Subject: Exhaust Discharge Location

Models Affected: Specific Freightliner Business Class M2 and Cascadia vehicles manufactured June 2, 2011, through October 29, 2014, and equipped with CNG fuel tanks.

February 2015
FL671A-G
NHTSA #14V-680
Transport Canada #14-547

Fig. 1, Exhaust Pipe Installation, Two Hangers

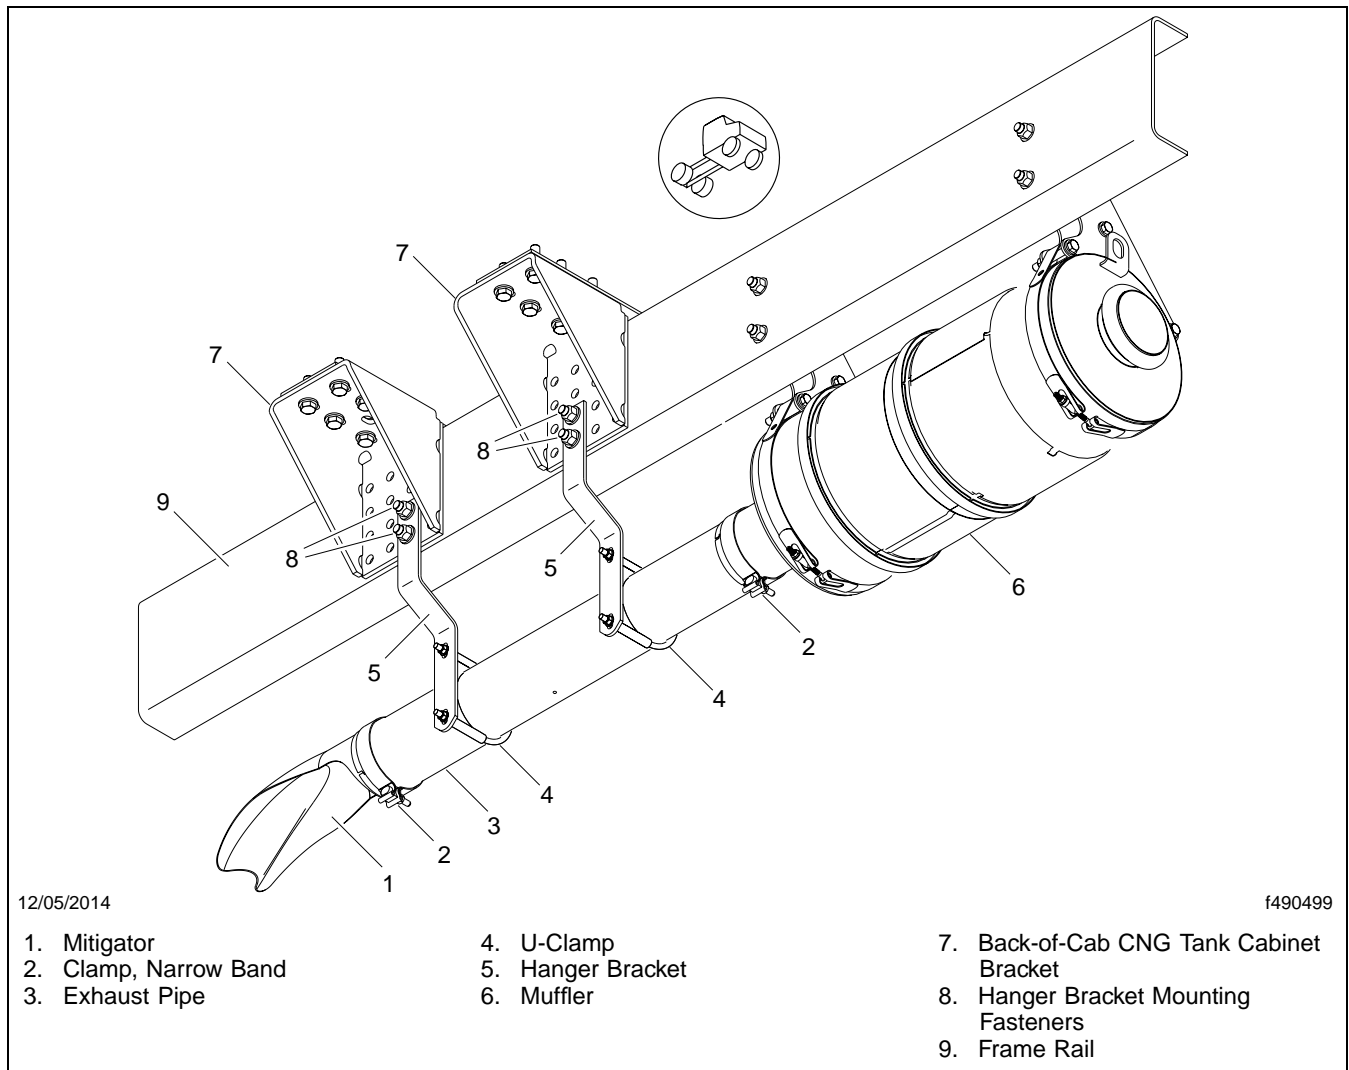
3. Remove the existing exhaust pipe and mitigator. Save the mitigator for reinstallation. Discard the clamps and pipe.
4. Vehicles in FL671A-C require two hanger brackets. Refer to **Fig. 1** on page 8 for installation, then proceed to step 5 on page 10.

Fig. 2, Exhaust Pipe Installation, One Hanger

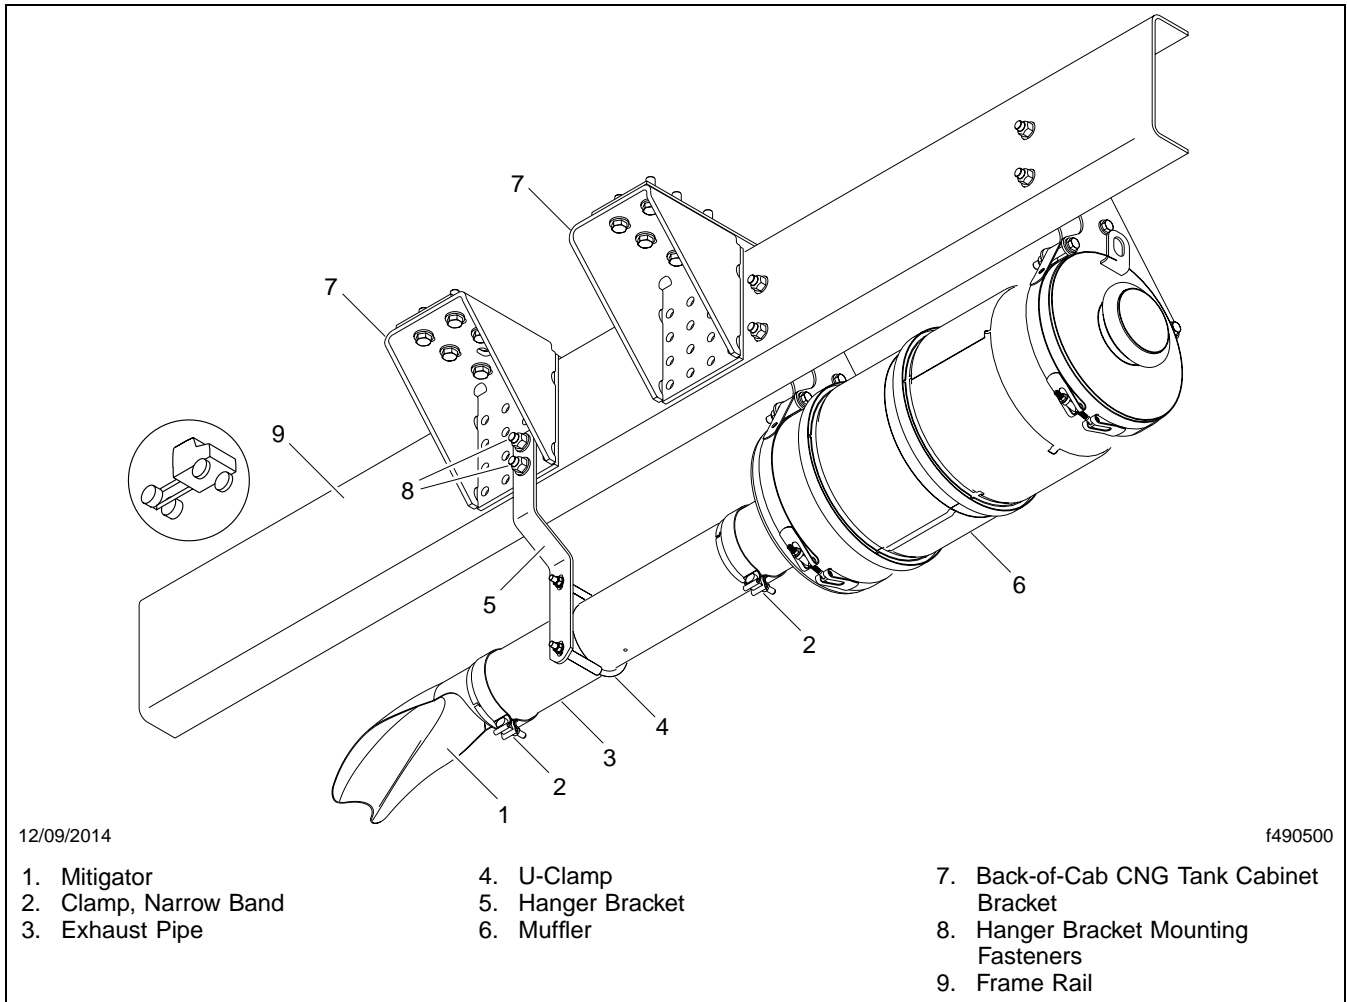
Vehicles in FL671D-F require one hanger bracket. Refer to **Fig. 2** on page 9 for installation, then proceed to step 5 on page 10.

Fig. 3, Exhaust Pipe Installation, No Hangers

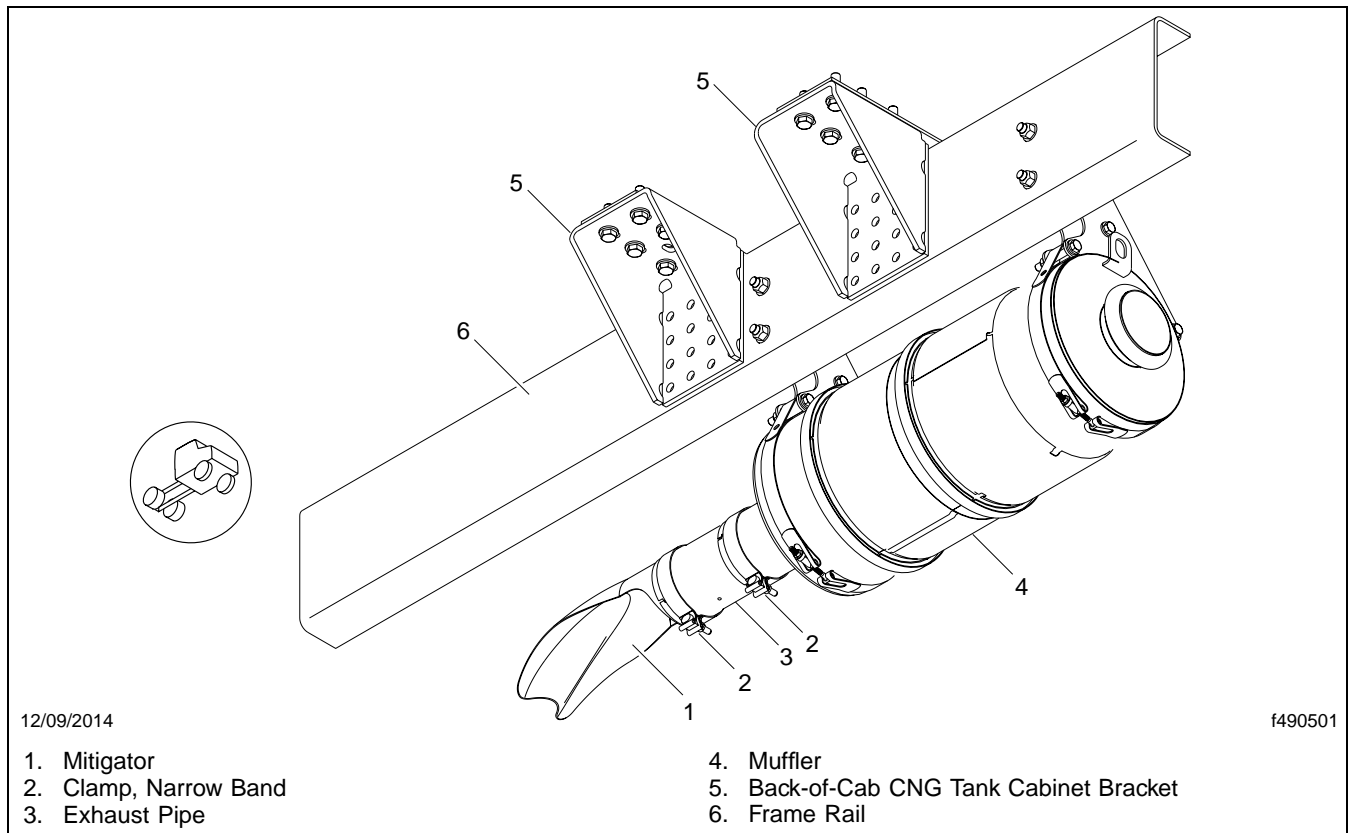
Vehicles in FL671G do not require a hanger bracket. Refer to **Fig. 3** on page 10, then proceed to step 9 on page 11 for installing the tailpipe extension.

Fig. 4, Determining the Hanger Locations

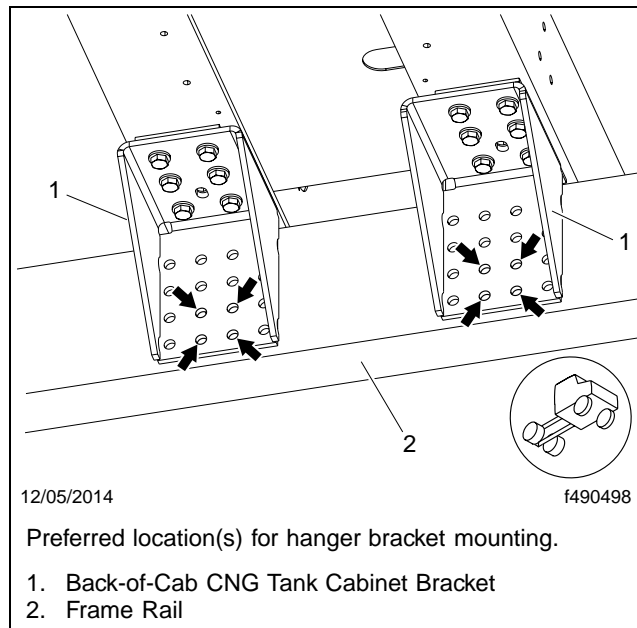
6. Determine the best location for the hanger bracket(s). Where possible, use the existing holes in the back-of-cab tank cabinet mounting bracket(s). See **Fig. 4**.
7. Using the existing holes in the back-of-cab CNG tank cabinet mounting bracket as a guide, drill additional holes in the frame rail as needed to mount the hanger brackets.
8. Install the required hanger bracket(s) using the nuts, bolts, and washers from the hardware kit. Tighten the mounting nuts and bolts 128 lbf-ft (173 N·m).
